The Borough of Hightstown Historic Preservation Committee

Historic Preservation Committee Meeting Minutes December 16, 2021

- Banners a PO was placed with futuresigns to replace 10 banners JH to email Chief Gendren about escorting install.
- Monument JH to notify MO that receipts were submitted, Dennis needs reimbursement
- Peddie Bridge Update:

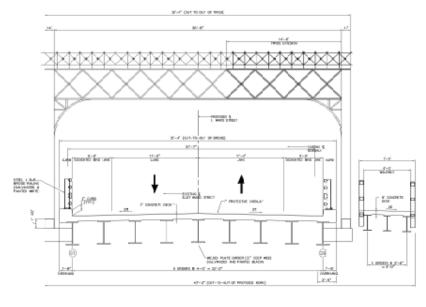
HPC opinion: Option widening 2 as described below, as the difference is only 4 ft from needed 3ft shoulders. HPC will write up an opinion, and include comments about architectural lighting and push for truck traffic control over the bridge and elsewhere in town- we should provide ideas for traffic control.

Attached is a concept drawing of the **Option 2 widening, which is currently the leading contender because of Complete Streets.** Please don't get sidetracked by the description in the title block of this project as a "Bridge Replacement" ... that's engineering for relieving the trusses of a live load but we will be retaining all of the surviving truss fabric of 1896 as

self-supporting. All of the surviving features will be preserved except for the width proportion. The bridge will look as is today from both elevations up and downstream. We will even have some opportunity to restore steel fabrication details in the trusses that have been altered/damaged by past welding repairs or corrosion.
